**ADDENDUM NO. 3
TO THE
SPECIFICATIONS, PROPOSAL, AND CONTRACT DOCUMENTS**

**TOTEM LAKE CONNECTOR BRIDGE
JOB # 01-20-PW/NMC0861000**

CITY OF KIRKLAND, WASHINGTON

ITEM NO. 3: Revised Plan Sheets

CITY OF KIRKLAND
 TOTEM LAKE PEDESTRIAN BRIDGE
 DEMOLITION AND EROSION CONTROL PLAN 4

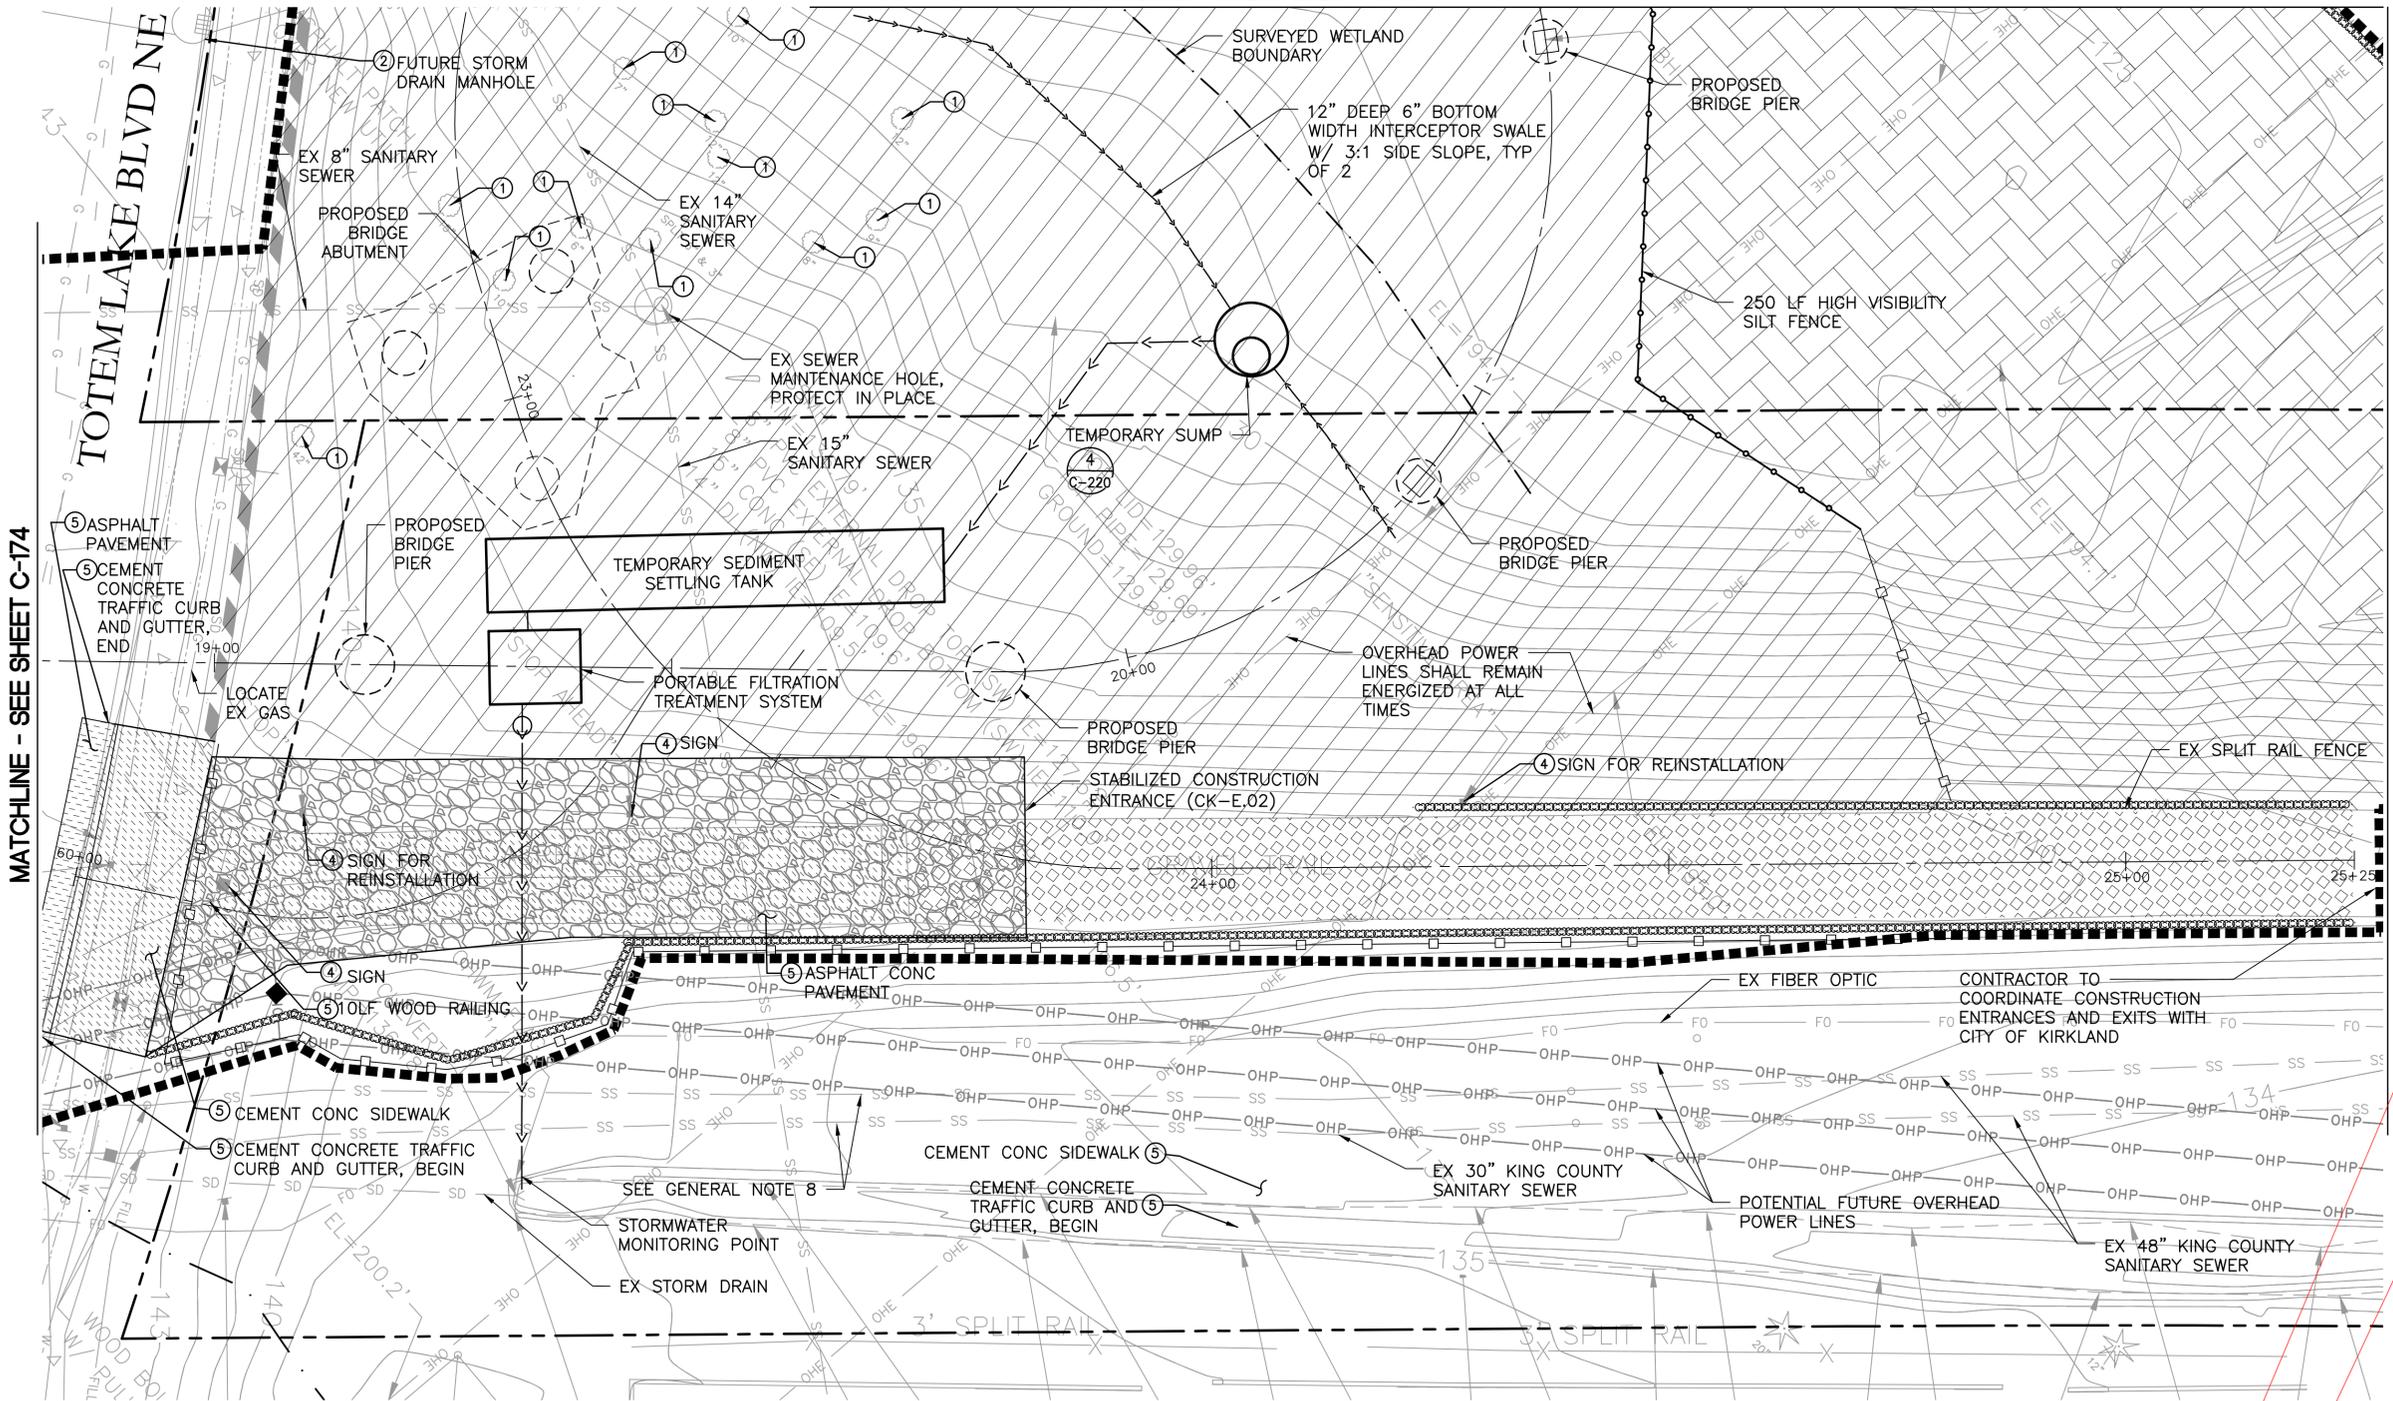
⚠
 Revise General Note 7 to read:
 "SEE SPECIAL PROVISIONS FOR HANDLING, TESTING, CHARACTERIZATION, AND DISPOSAL OF IMPACTED SOILS."

⚠
 Revise General Note 10 to read:
 "SEE APPENDIX TO PROJECT MANUAL FOR LABORATORY ANALYSIS AND TEST RESULTS OF IMPACTED SOILS."

CITY OF KIRKLAND
TOTEM LAKE PEDESTRIAN BRIDGE
DEMOLITION AND EROSION CONTROL PLAN 5

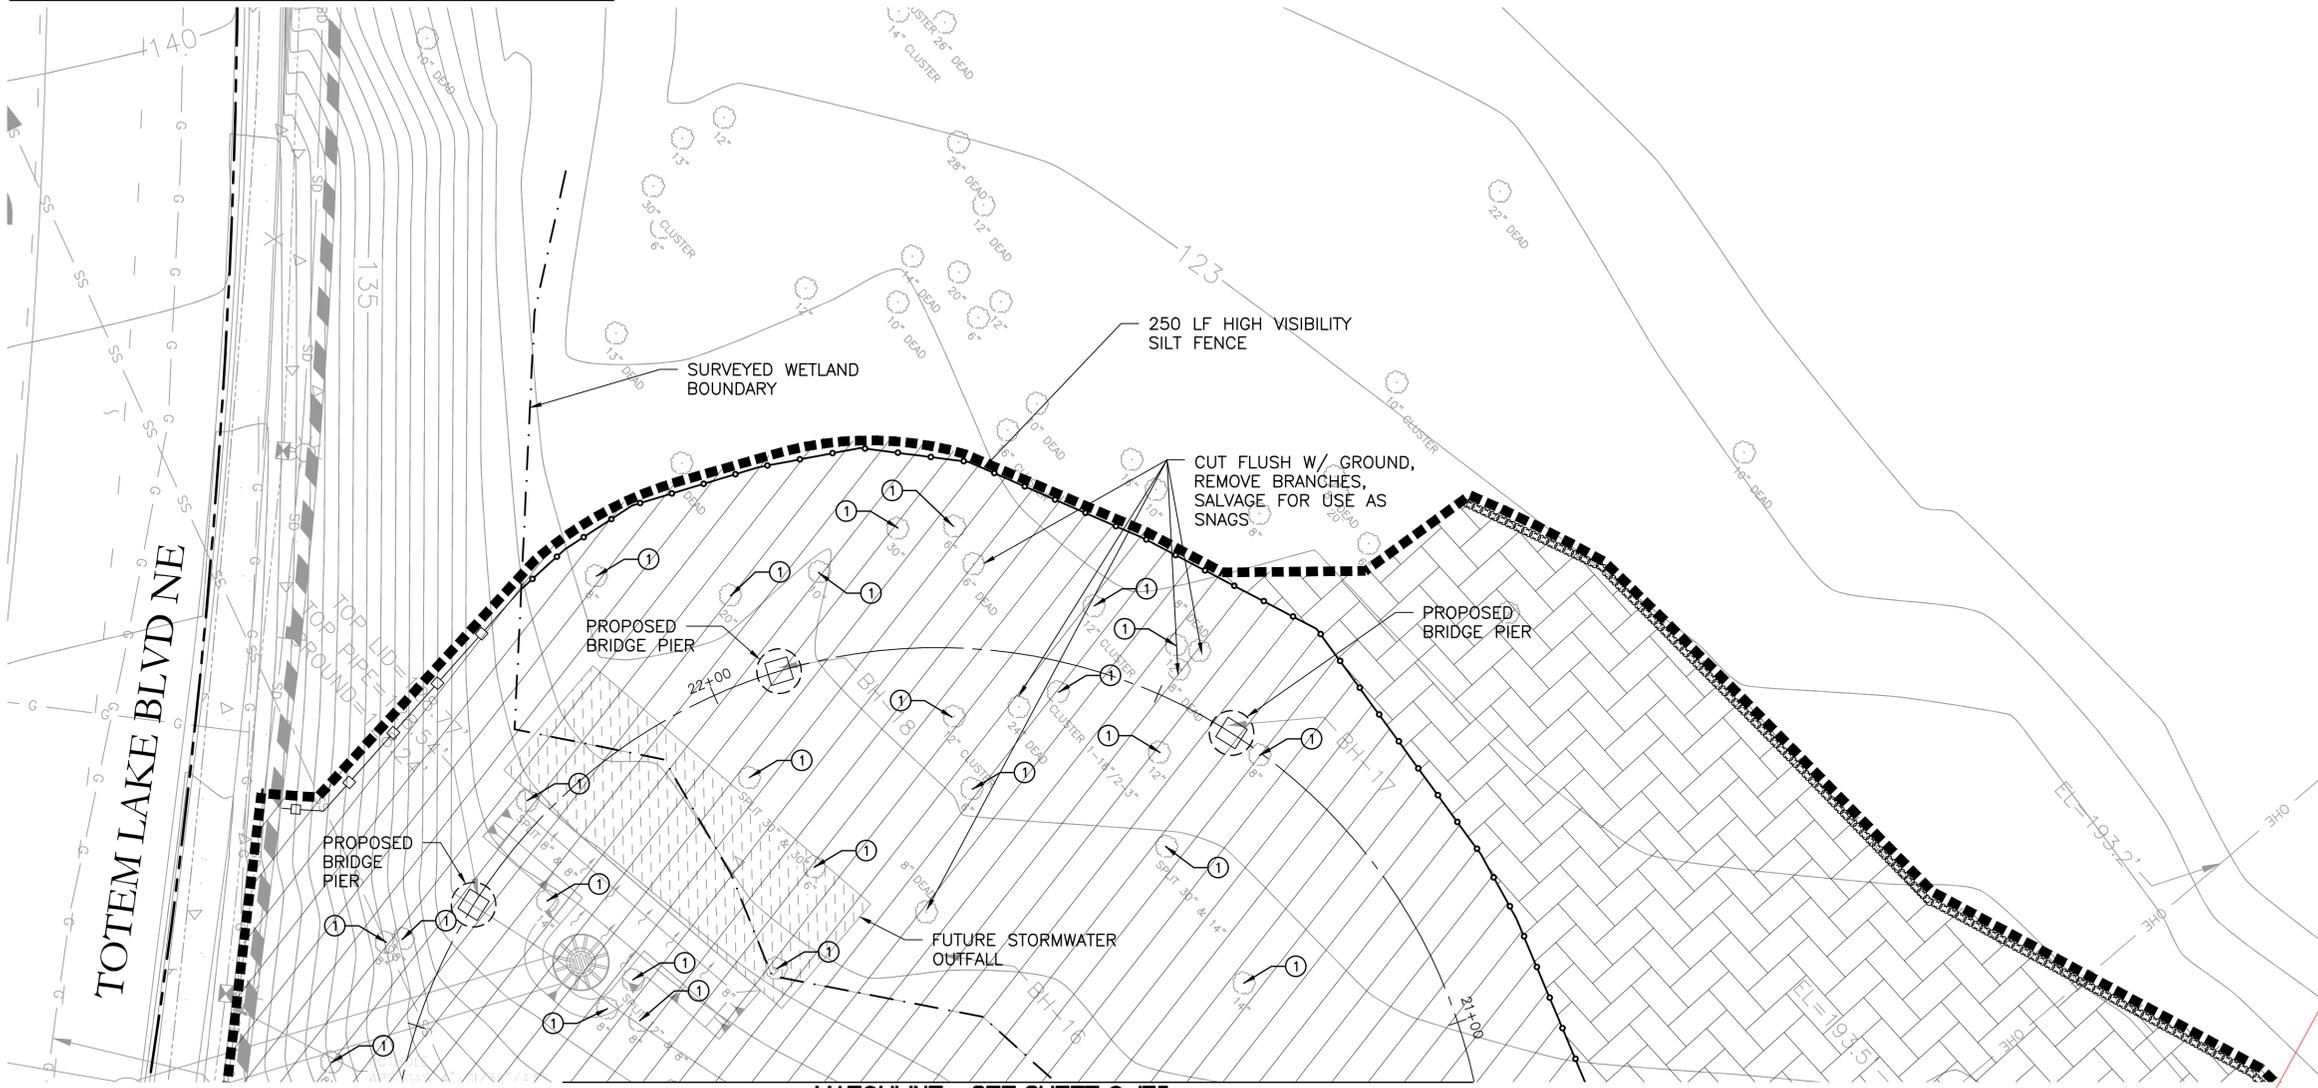
⚠️ **Revise General Note 7 to read:**
"SEE SPECIAL PROVISIONS FOR HANDLING, TESTING, CHARACTERIZATION, AND DISPOSAL OF IMPACTED SOILS."

⚠️ **Revise General Note 10 to read:**
"SEE APPENDIX TO PROJECT MANUAL FOR LABORATORY ANALYSIS AND TEST RESULTS OF IMPACTED SOILS."

CITY OF KIRKLAND
TOTEM LAKE PEDESTRIAN BRIDGE
DEMOLITION AND EROSION CONTROL PLAN 6

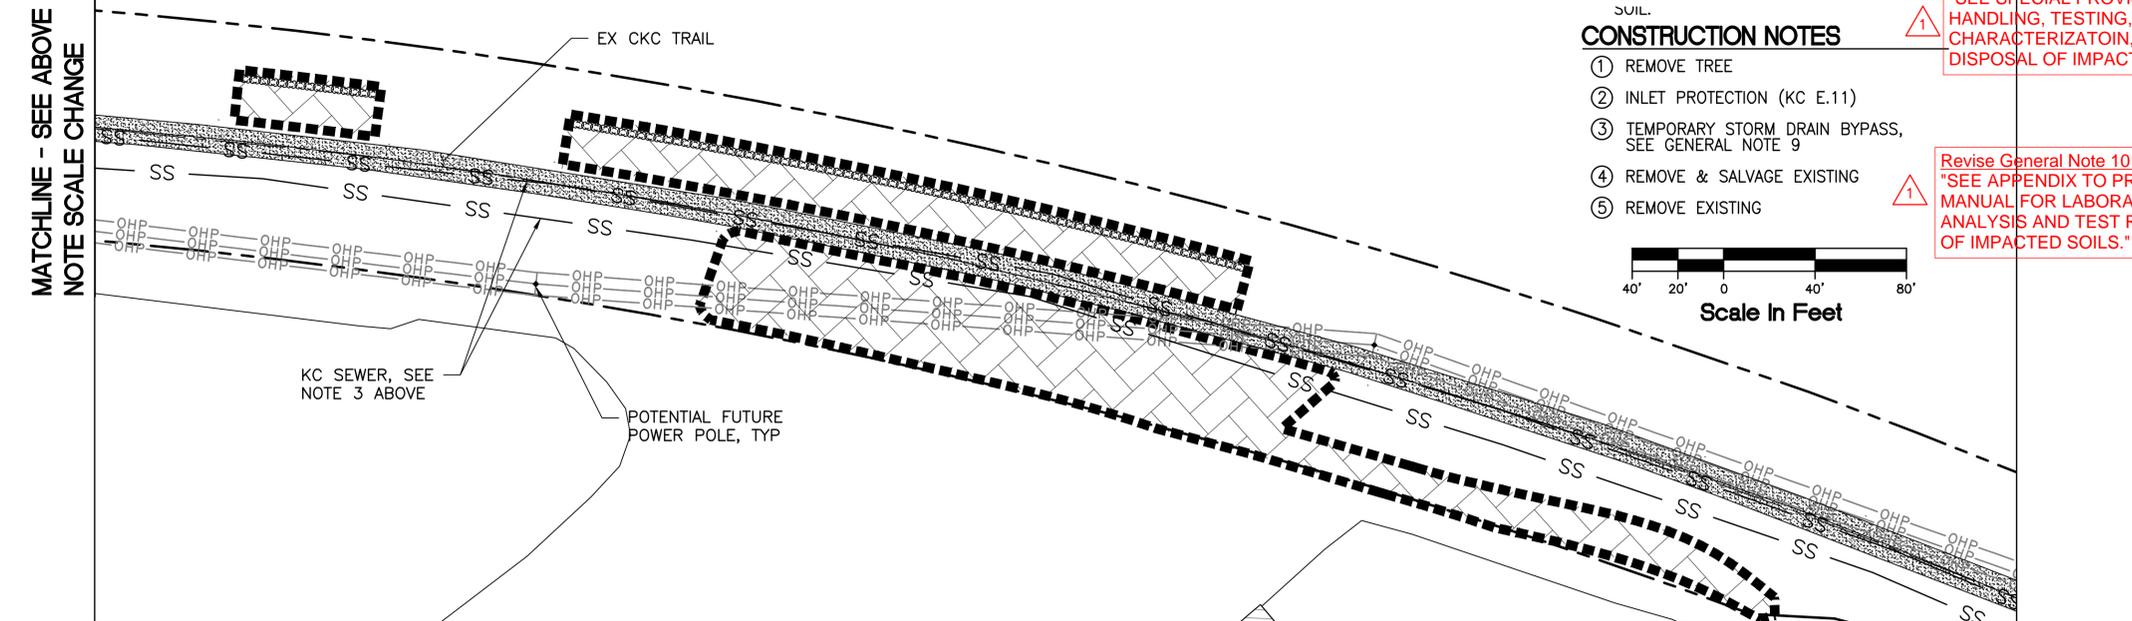
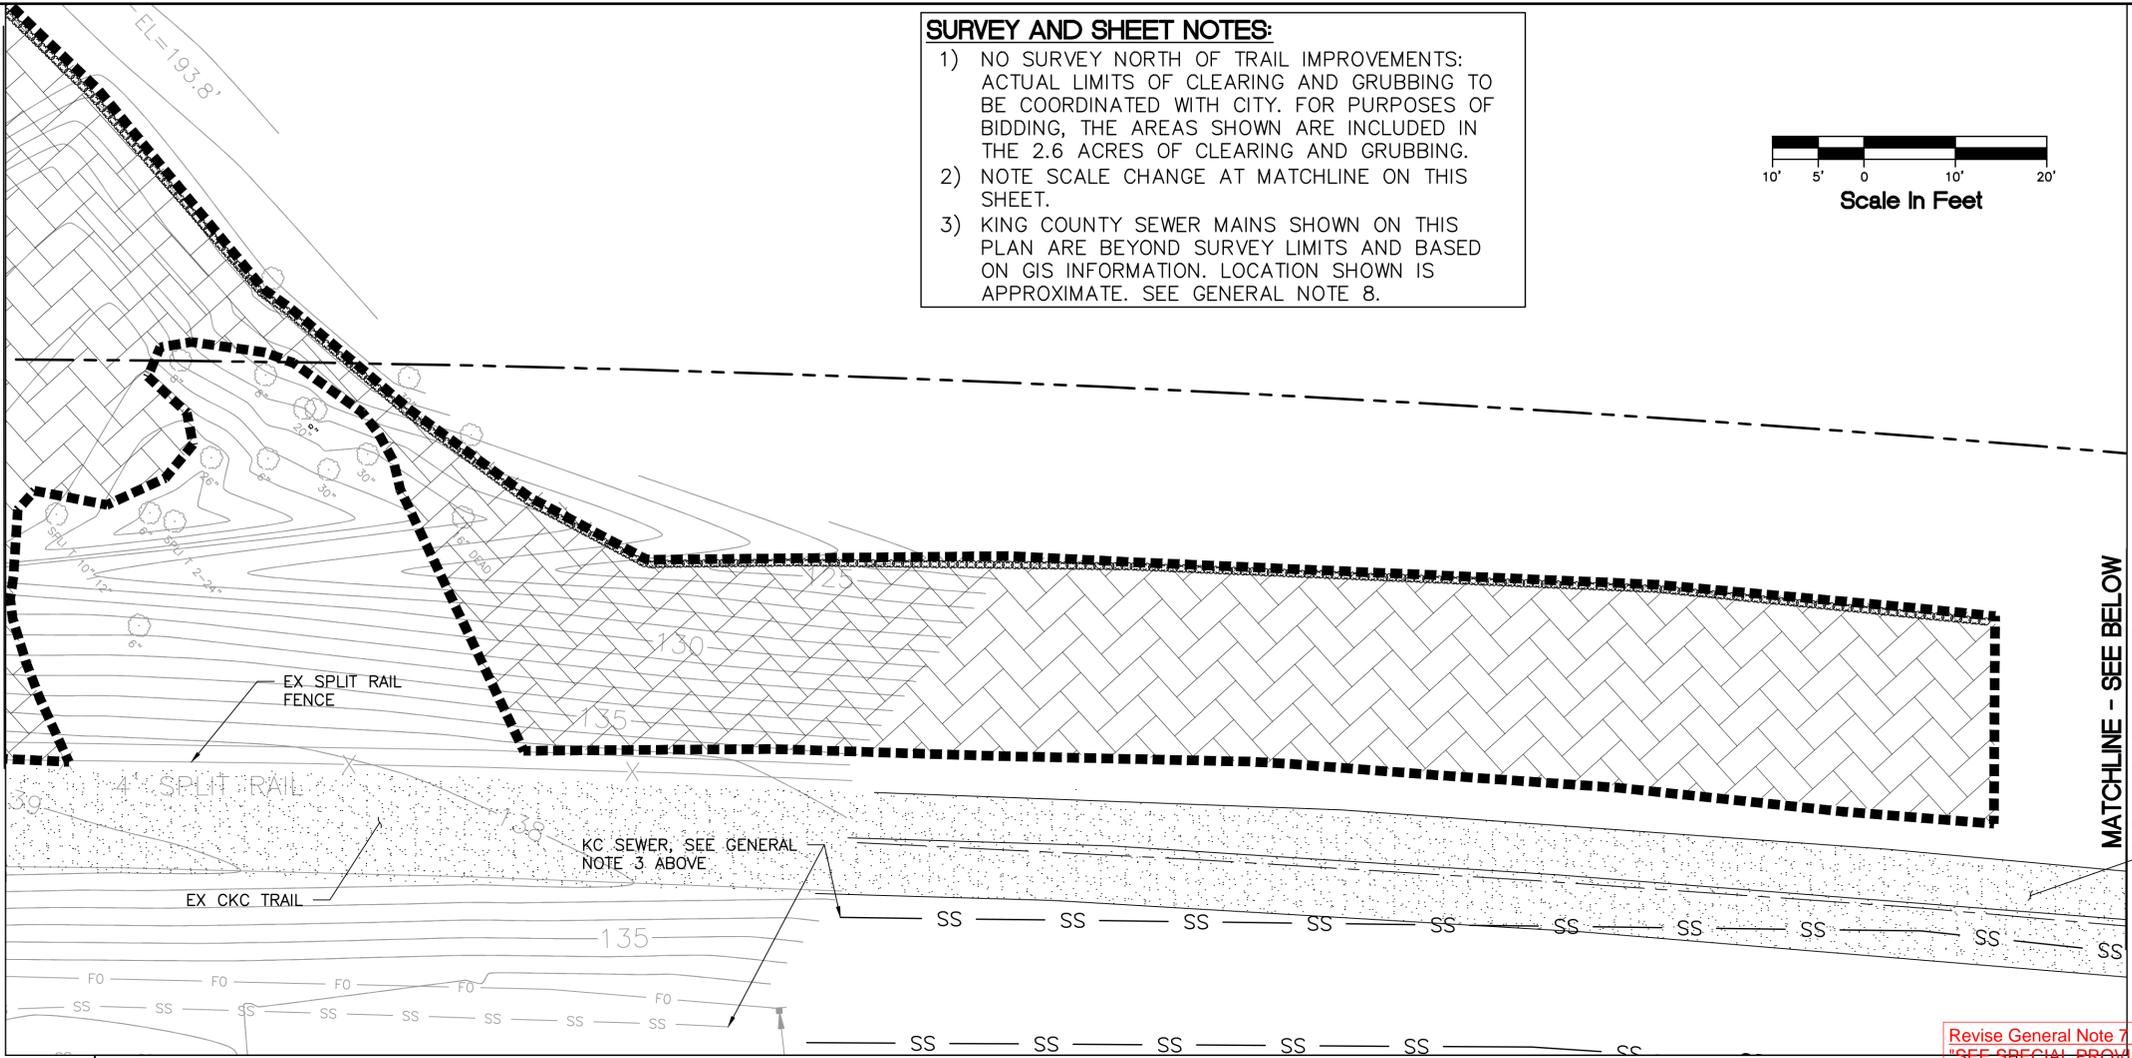
⚠ **Revise General Note 7 to read:**
"SEE SPECIAL PROVISIONS FOR HANDLING, TESTING, CHARACTERIZATION, AND DISPOSAL OF IMPACTED SOILS."

⚠ **Revise General Note 10 to read:**
"SEE APPENDIX TO PROJECT MANUAL FOR LABORATORY ANALYSIS AND TEST RESULTS OF IMPACTED SOILS."
